Te Awamutu Waste to Energy Plant Groundwater Assessment

GROUNDWATER ASSESSMENT

WGA222576-RP-HG-0001_A

August 2023

Figure 2: Historical Aerial imagery from 1944 Adapted from HGGeo 2021.

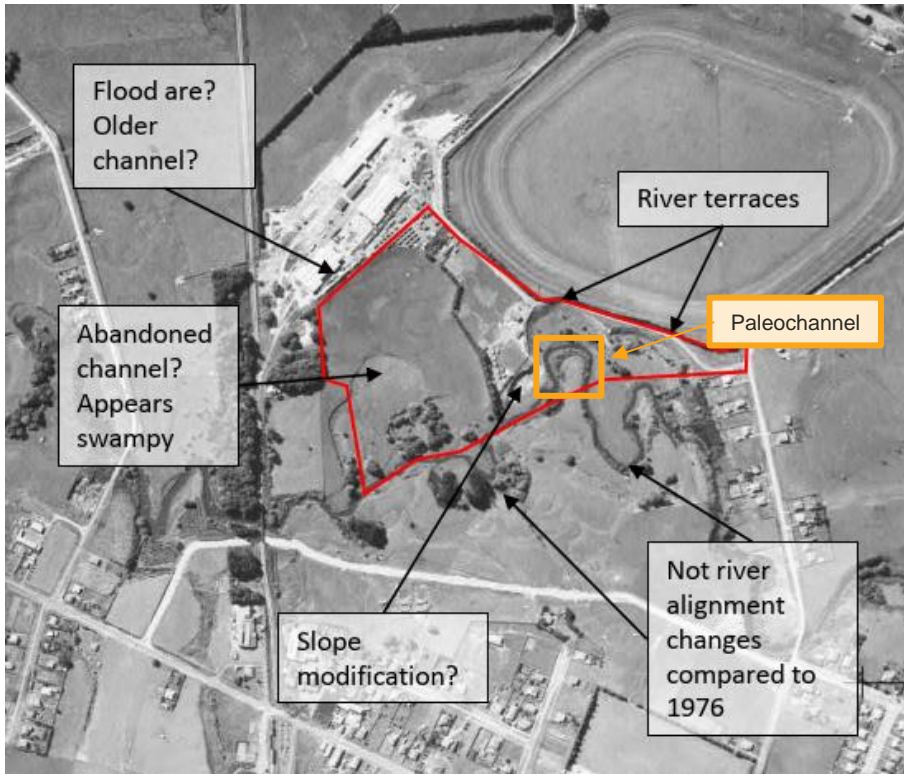
“At Section G, where the ditch is currently controlling seepage at the base of the scarp, the ditch would be replaced by the flood mitigation basin which would then receive the seepage.”

WGA notes that this ‘drainage ditch’ is a paleochannel as identified in HDGeo 2021 (Figure 2). The lower terrace ditch receives both groundwater and runoff water. Therefore, WGA considers that there are currently groundwater discharges at the site.

SECTION B (5x VERTICAL EXAGGERATION)
1:1000H 1:200V @ A1 (DOUBLE FOR A3)

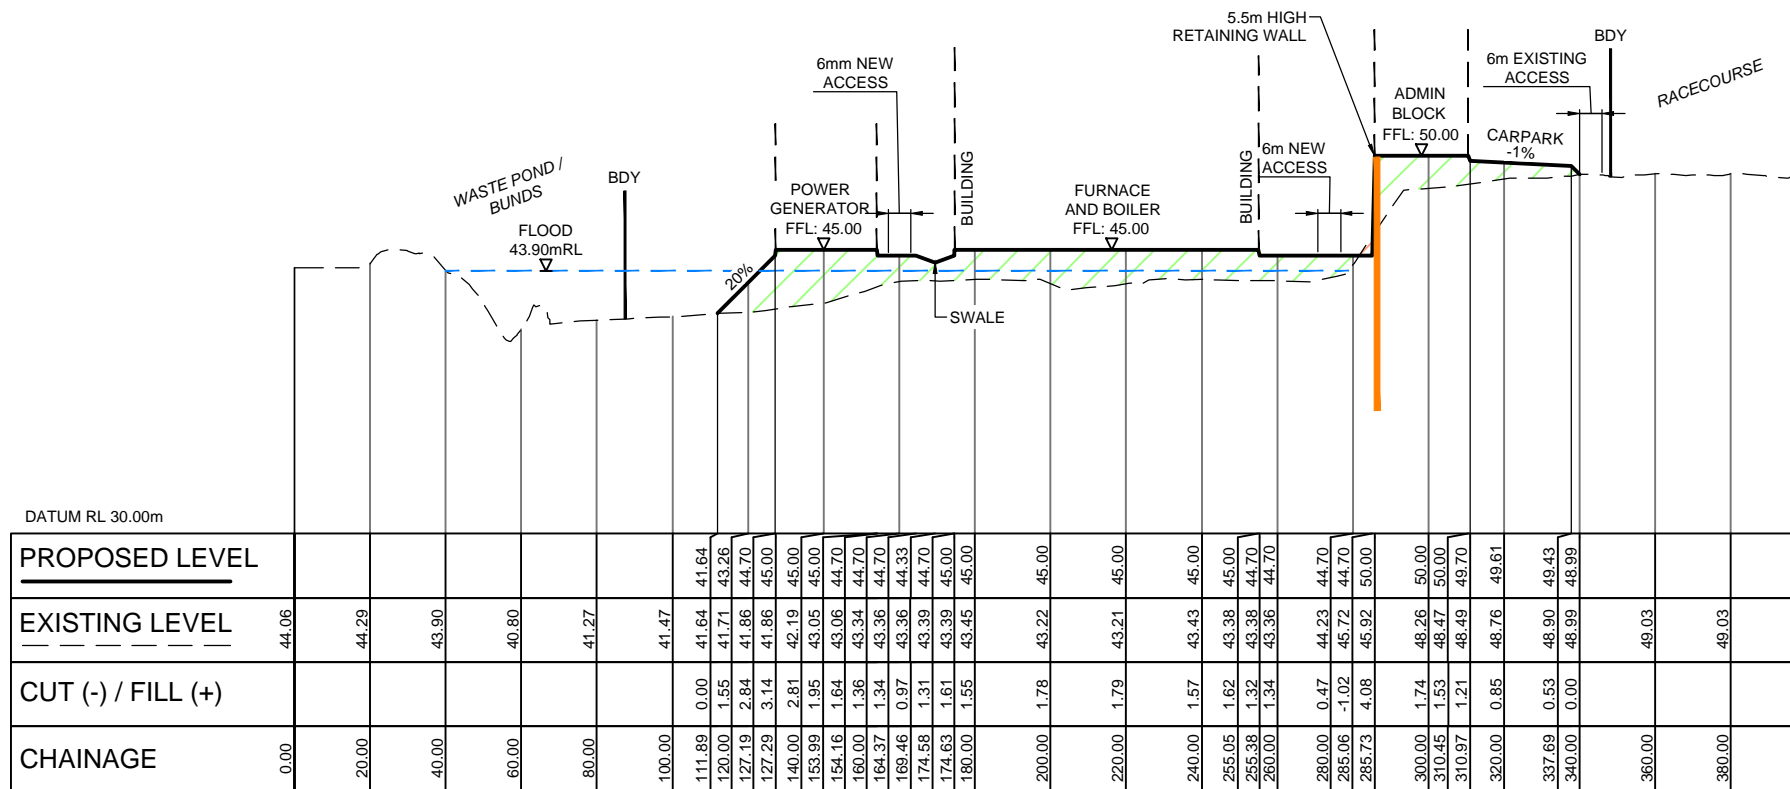
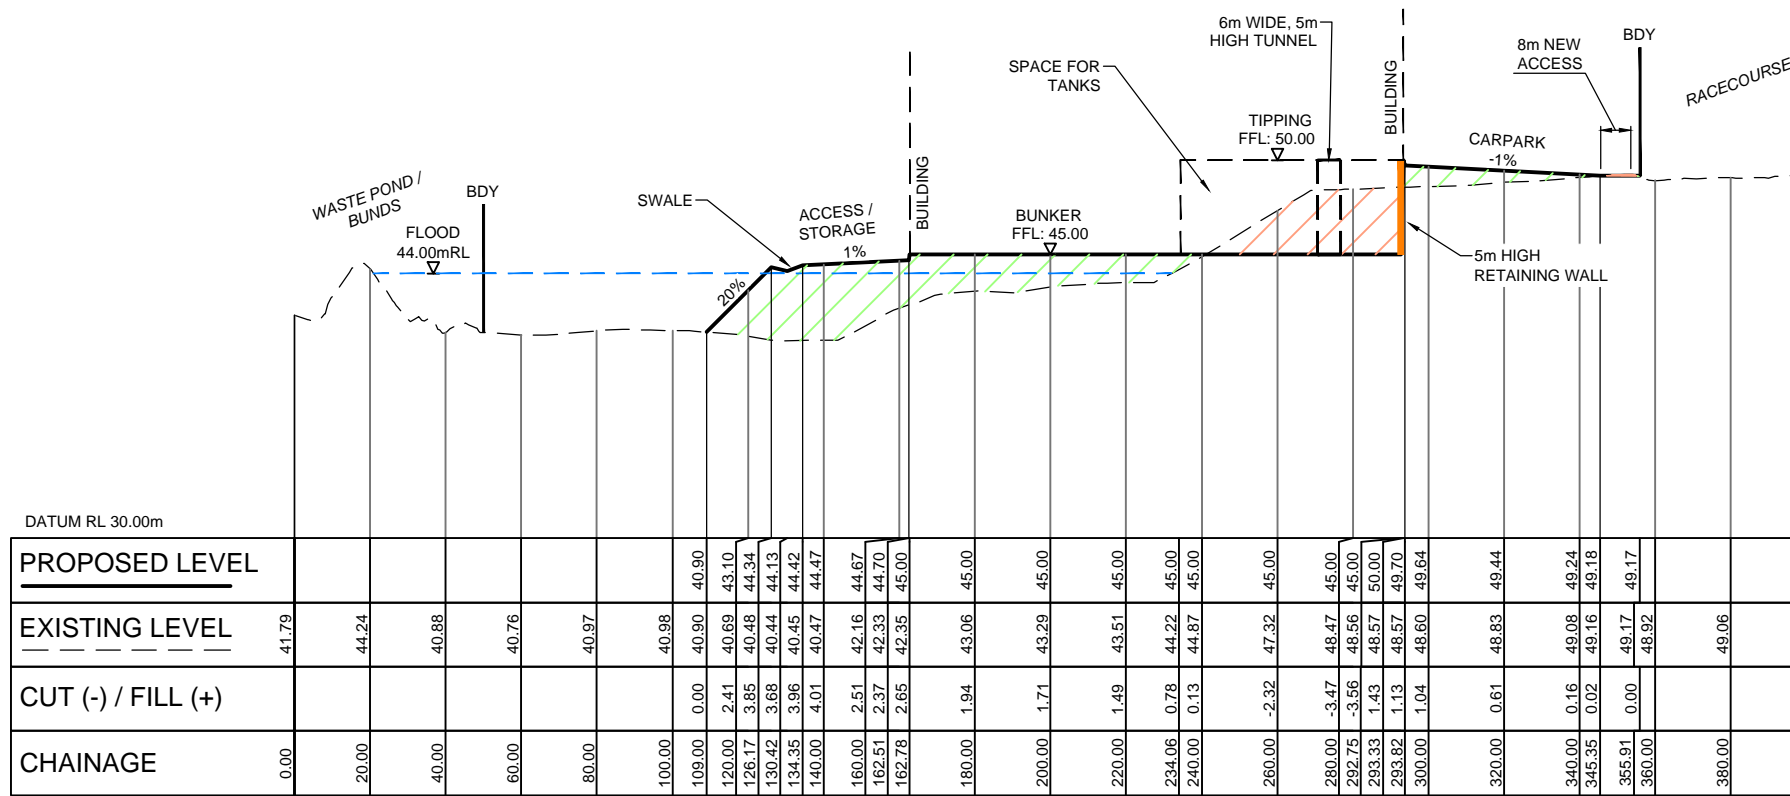
- a. Section B acknowledges the shallow water table at around 0.5 m bgl in this area showing the water table above the invert 1 level. Planting in this area is also planned as a wetland.*

DRAWING TITLE
TYPICAL SECTION C AND D

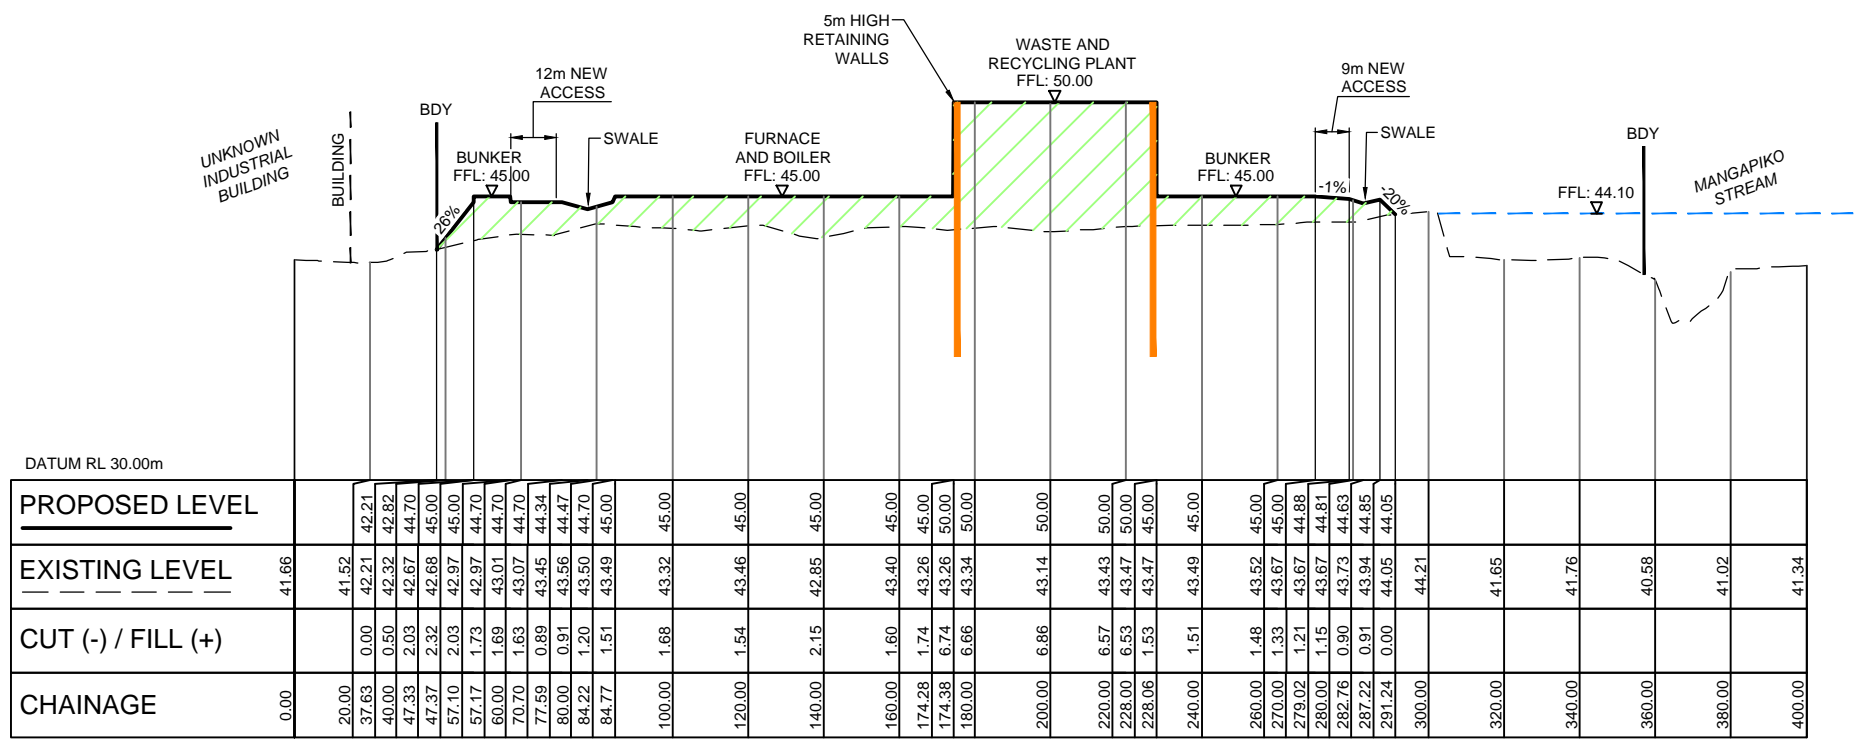
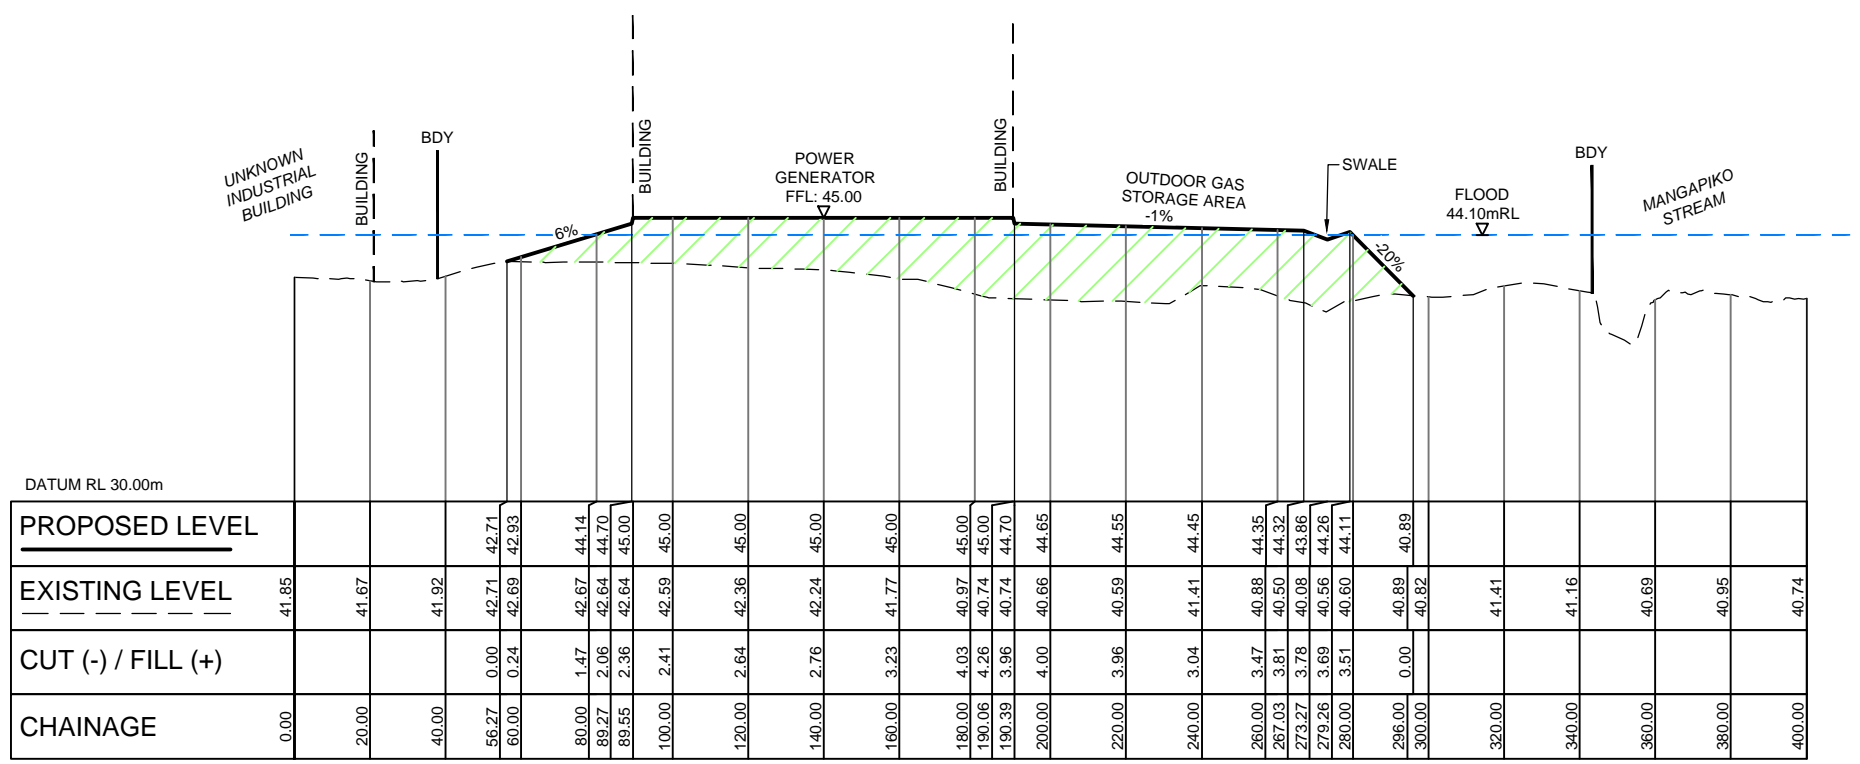
- b. Extrapolation of the 40 m water level contour at Section C indicates that the water table is likely around 1 m below the flood plain which would put the water table above the invert level of the flood mitigation basin.*

- c. Extrapolation of the 41 m water level contour indicates that the water table would be approximately 1 m or less below the flood plain in the vicinity of Section D and above the invert level of the flood mitigation basin.*

“In DWG No RC-012, 013 and 14 (Rev C) indicative groundwater levels are shown in some of the cross sections. In Sections C and D, the invert level of the flood displacement mitigation is at a similar level to the indicative groundwater level. The groundwater level is likely to fluctuate seasonally, therefore there is a likelihood that the flood displacement mitigation areas could experience ponding and the flood displacement mitigation will not be fully effective. Sections F and G do not show indicative groundwater levels as the groundwater contours in plan DWG RC-045 do not cover this area, however the invert of the flood displacement mitigation is at similar levels to the stream invert so there is also a risk that groundwater levels will cause ponding that will reduce the amount of flood displacement mitigation available in a flood.”

WGA understands that outlets to the flood mitigation basins will be installed to maintain groundwater level at or below the basin invert levels. With these additions to the basin design the basins should retain their active flood storage volume.

DRAWING TITLE
TYPICAL SECTION E AND F

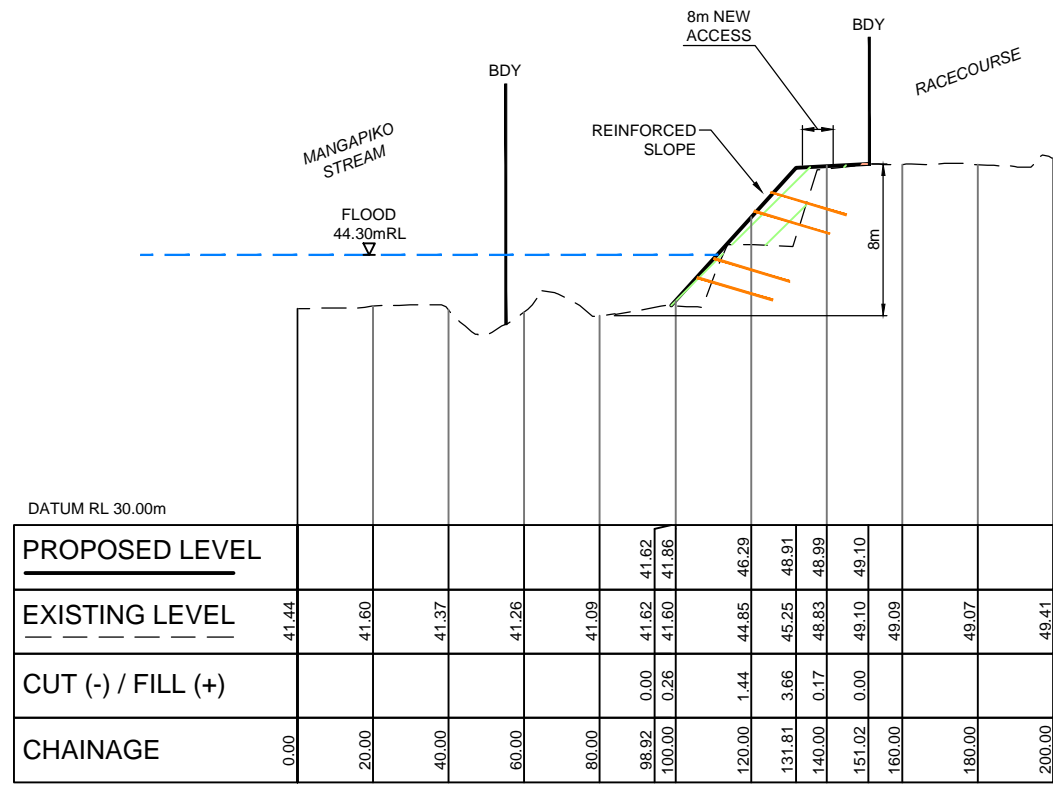
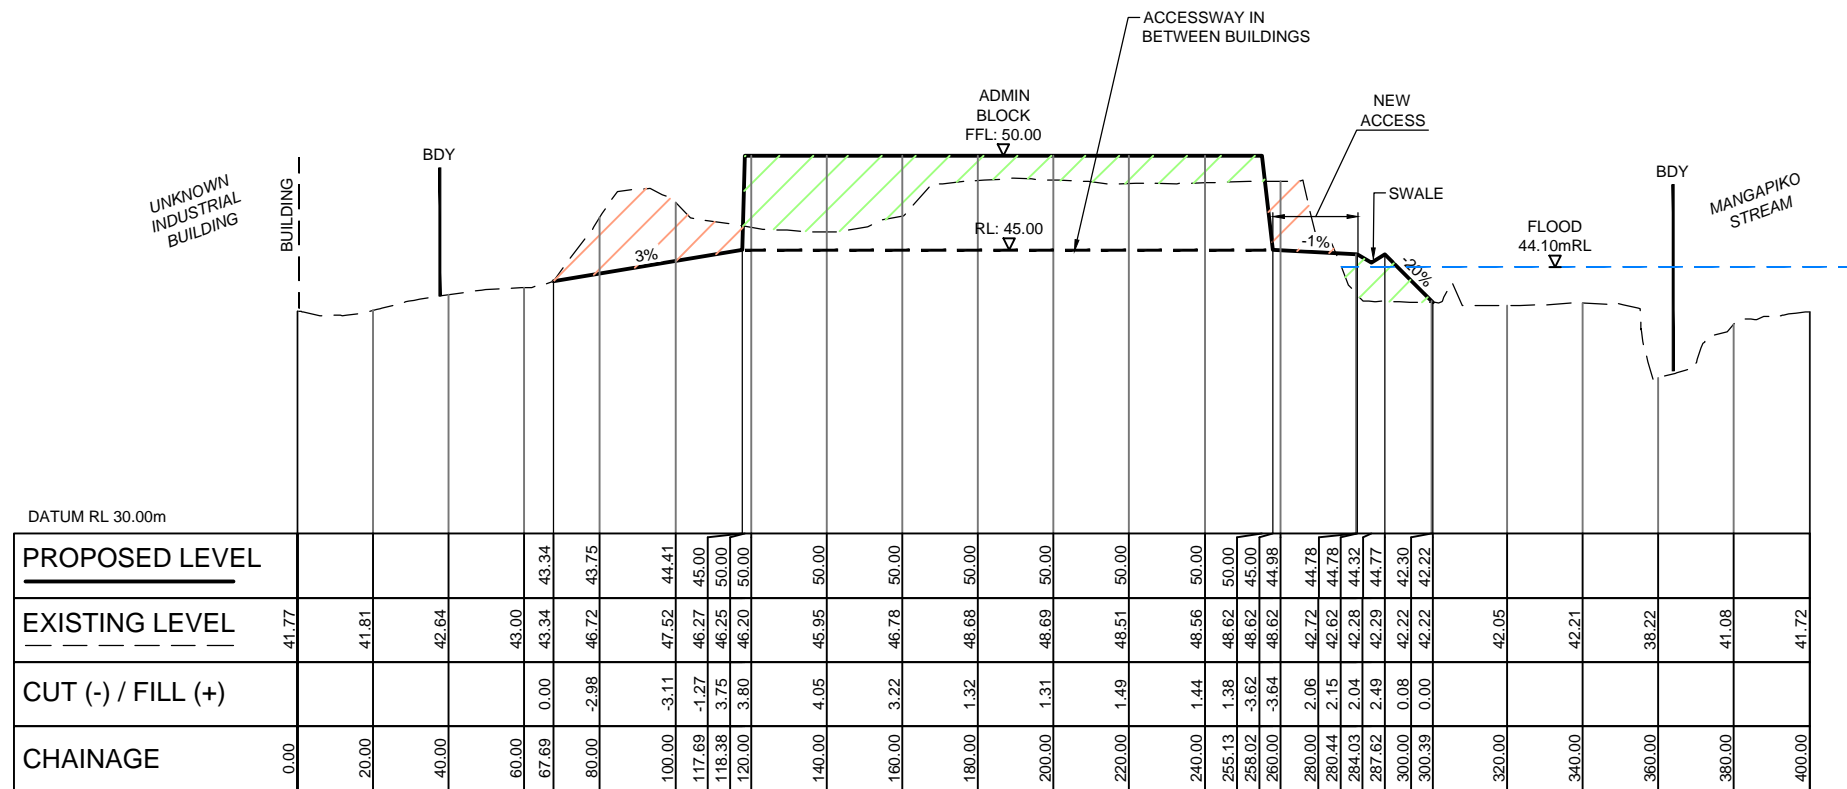
- e. At Section E the water table contours are likely to be at approximately 42 m which is above the base of the invert.*
- f. At Section G, where the ditch is currently controlling seepage at the base of the scarp, the ditch would be replaced by the flood mitigation basin which would then receive the seepage.”*

SECTION G (5x VERTICAL EXAGGERATION)
1:1000H 1:200V @ A1 (DOUBLE FOR A3)

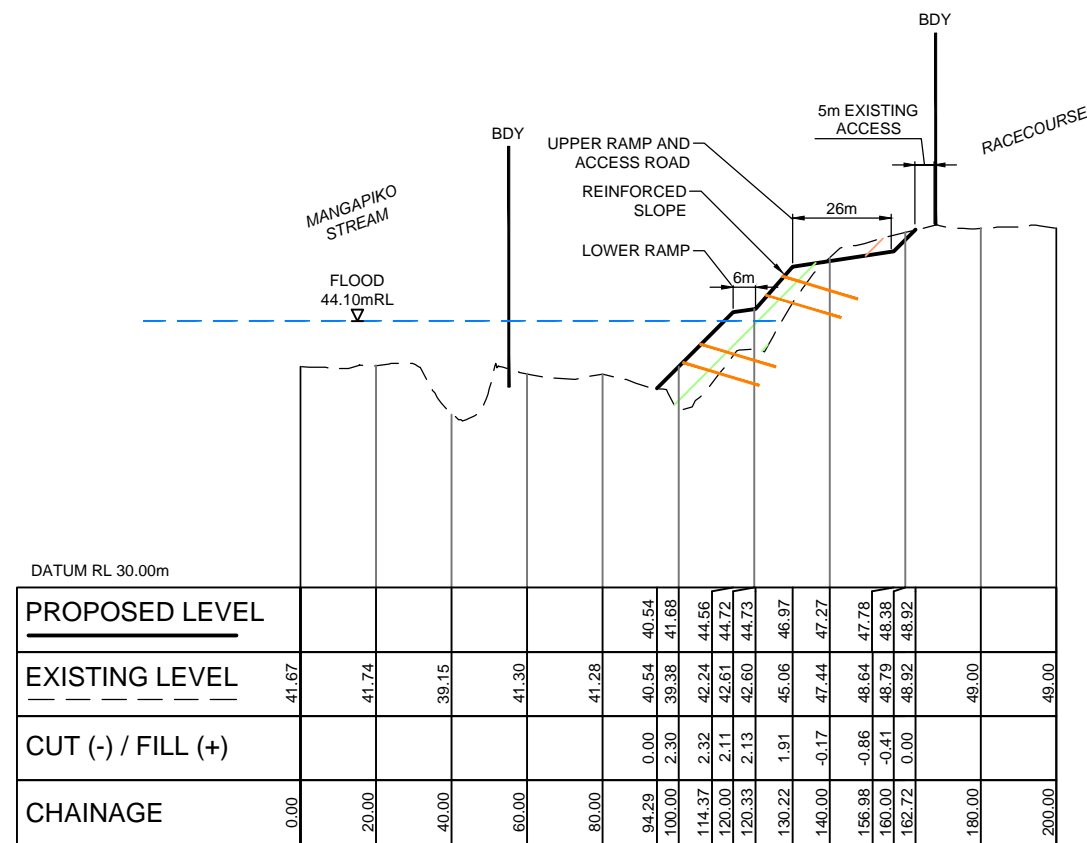
- d. Extrapolation of the 42 m and 43 m water level contours indicate that the contours are likely to “daylight” along the terrace scarp resulting in a seepage face, particularly at times of high water levels. The presence of a drainage ditch at the base of the scarp in the vicinity of Section G suggests that this seepage is occurring.*

“drainage ditch at the base of the scarp in the vicinity of Section G”

“... Mr Sheppard considers that this may have a limiting effect on the mitigating effect of the basins. No allowance for groundwater take has been included nor has an assessment of effects on groundwater from the potential groundwater take been undertaken. Seasonal groundwater highs have potential to exacerbate any effects. In this scenario the planned planting vegetation would need to be replaced by wetlands.”

Groundwater levels are not expected to be lowered to any significant amount due to the planned excavations (Appendix A). WGA understands that at least two or three outlets will be installed to discharge water from the basins to the stream. Groundwater seepage into the flood basins is expected but no long-term drawdown effect will be generated as the overflow levels will be similar to the current outflow level for the ‘drainage ditch’. The groundwater will be discharged to the local stream, effectively at the location where it would naturally discharge. Therefore, WGA does not consider that the proposed earthworks will generate an effect sufficient to require a “Groundwater Take” consent. Therefore, the water level in the basins will be maintained at the basin invert level, or below during naturally occurring dry conditions. By maintaining water levels at the basin invert the basins will maintain their active storage volume for mitigation of flood volumes.

In addition, WGA understands from the project’s landscape architect that wetland plantings will be used within the basins to enhance the natural stream environment and cope with any seepage.

In terms of seasonal “highs”, the recent groundwater level monitoring indicated groundwater levels during a particularly high rainfall period were still 0.5 m to 2.0 m below ground level on the lower terrace (Appendix B). Small fluctuations were observed in response to rainfall events over 43 days of monitoring. However, since the site is located near the stream discharge location this will maintain relatively stable groundwater levels. Therefore, WGA disagrees that seasonal groundwater highs have potential to exacerbate any effects.
